PENNSYLVANIA POWER & LIGHT COMPANY
ALLENTOWN, PENNSYLVANIA
SUSQUEHANNA STEAM ELECTRIC STATION - UNIT 1, UNIT 2

TITLE
1" HCB-108 WETWELL ATMOSPHERE
SAMPLE RETURN FROM ANALYZER

JOB NO 8856 DRAWING NO SP-HCB-108-1 REV 15

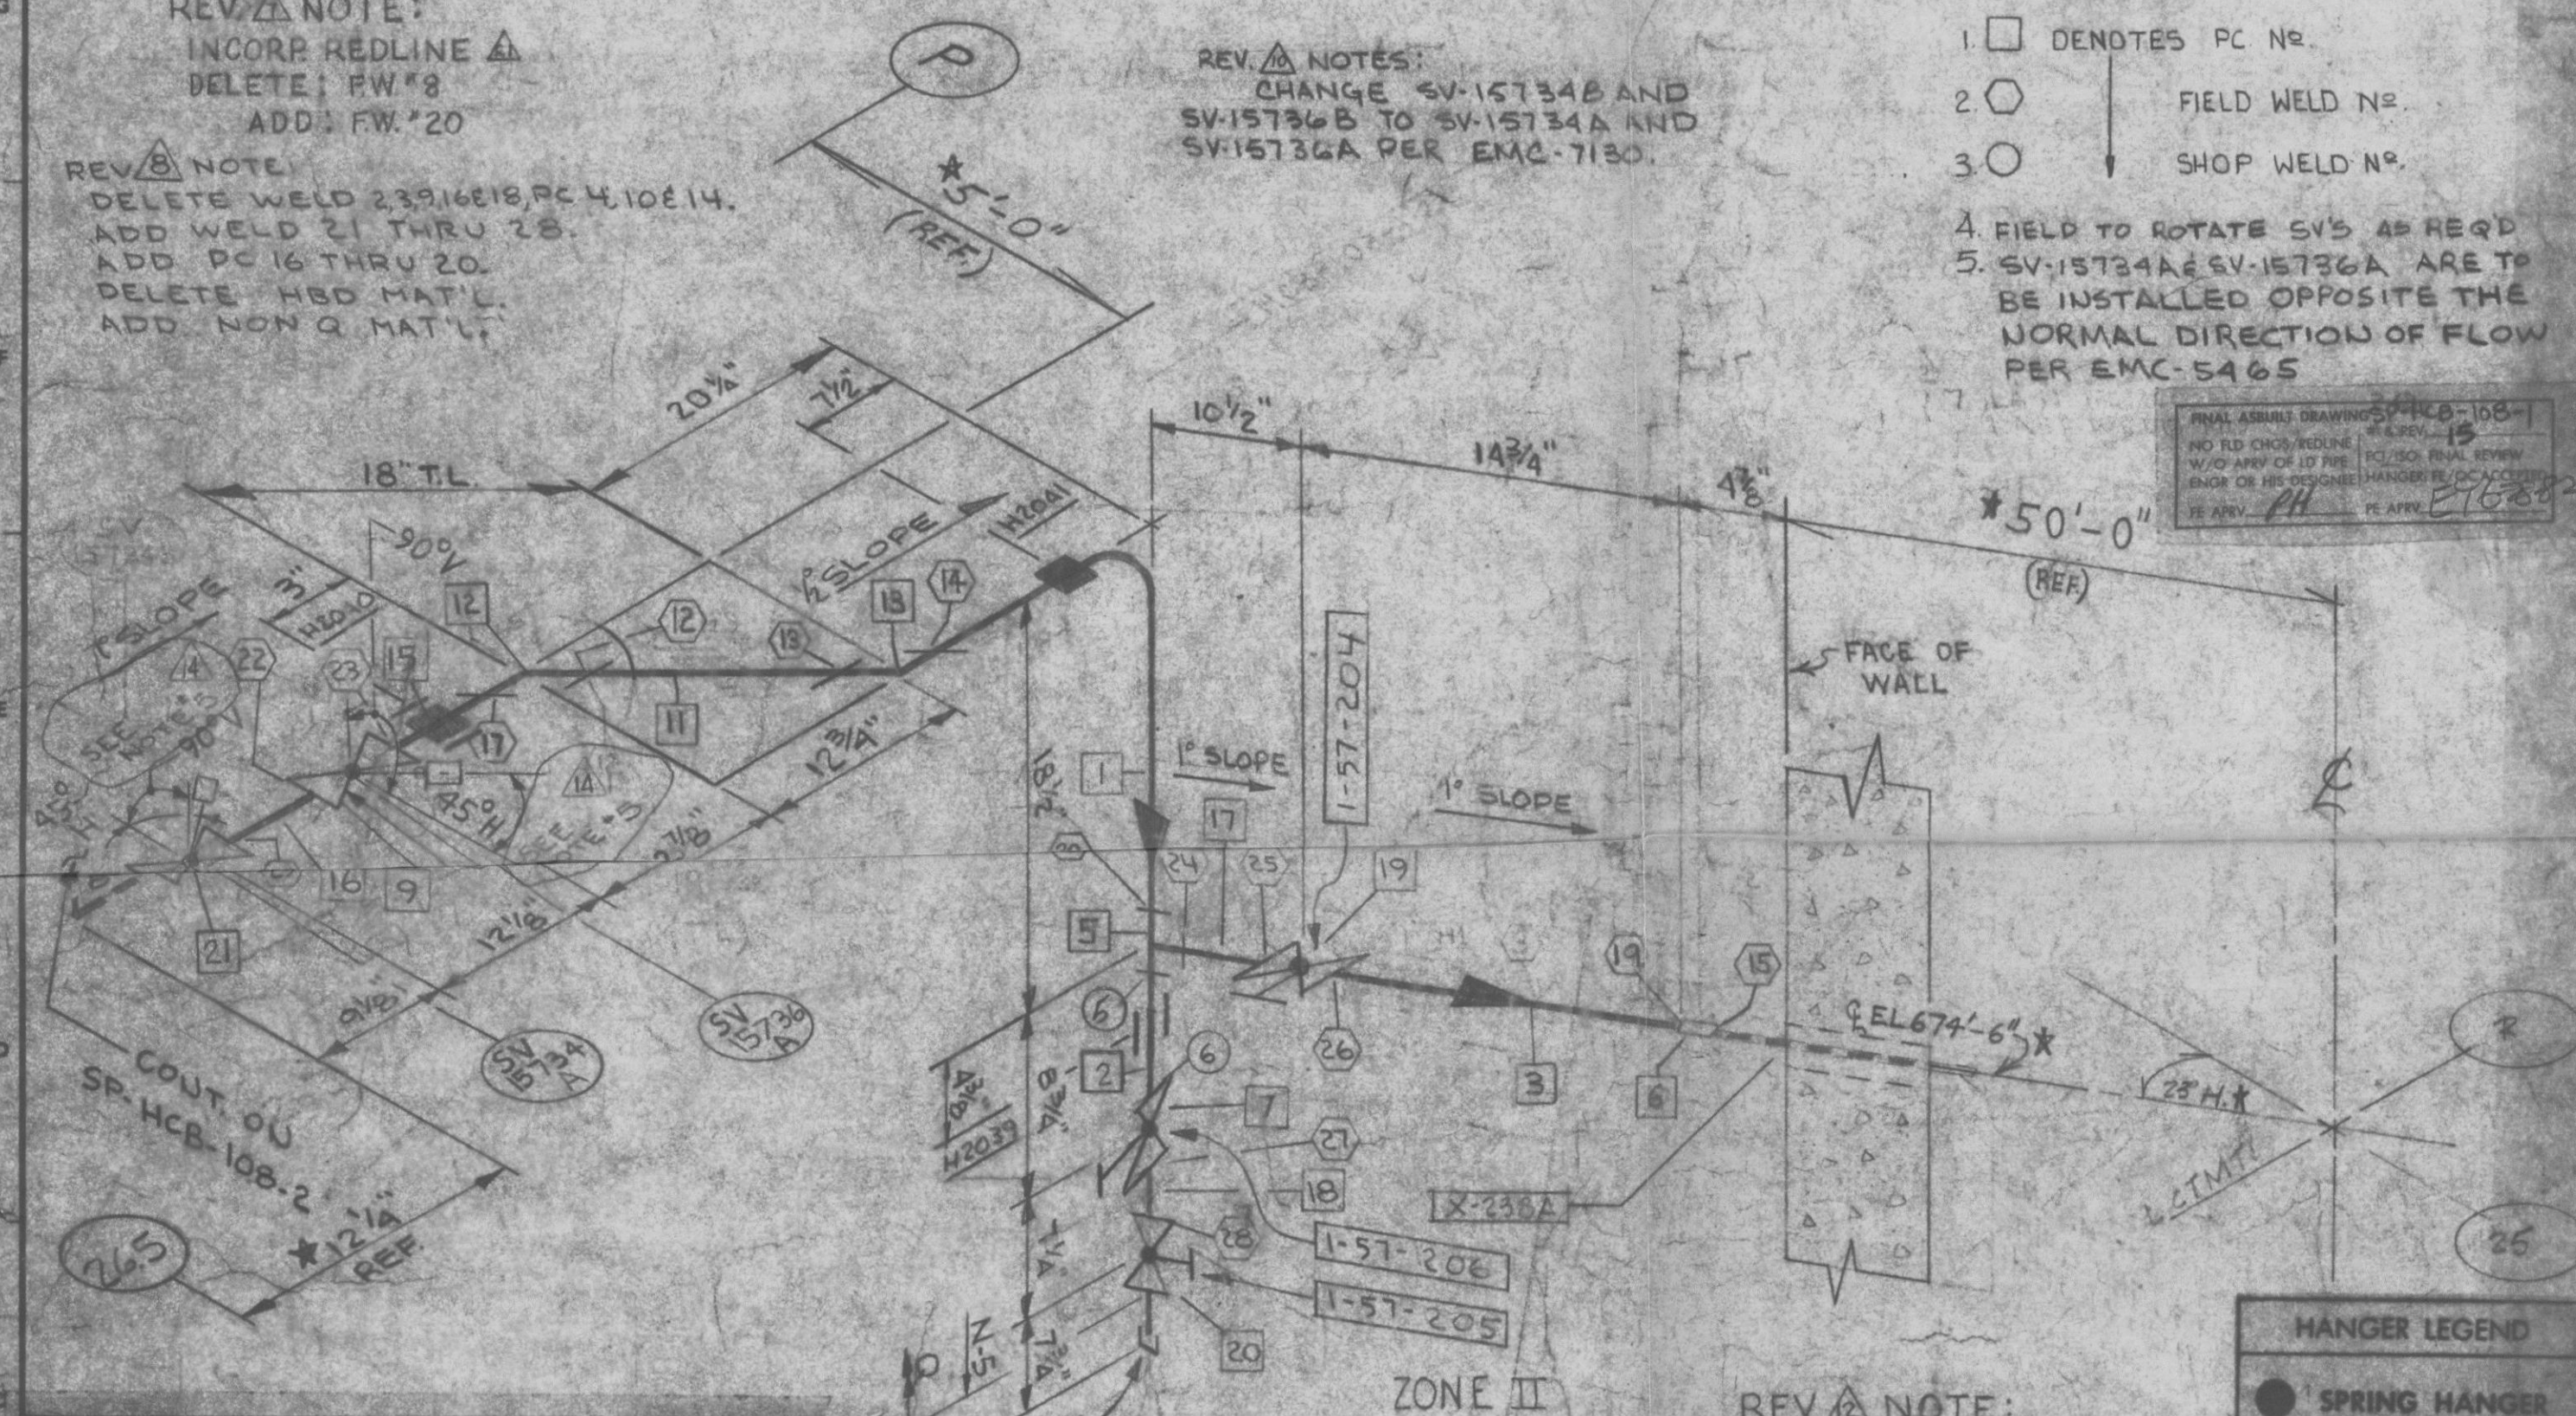
DELETED WELD 1
ADDED WELDS 11-THRU-15
ADDED PC 10-THRU-13

INCORP REDLINE
DELETE: FW#8
ADD: FW#20

DELETE WELD 2, 3, 9, 16, 18, PC 4, 10, 14.
ADD WELD 21 THRU 28.
ADD PC 16 THRU 20.
DELETE HSB MAT'L.
ADD NON Q MAT'L.

CHANGE SV-15734B AND SV-15736B TO SV-15734A AND SV-15736A PER EMC-7130.

REV. NOTE:
INCORP REDLINE
DELETE: PC#8 & FW#21
ADD: PC#21 & FW#29
PER SWA 11615 & SWR 4506
REV ORIENTATION OF VALVES
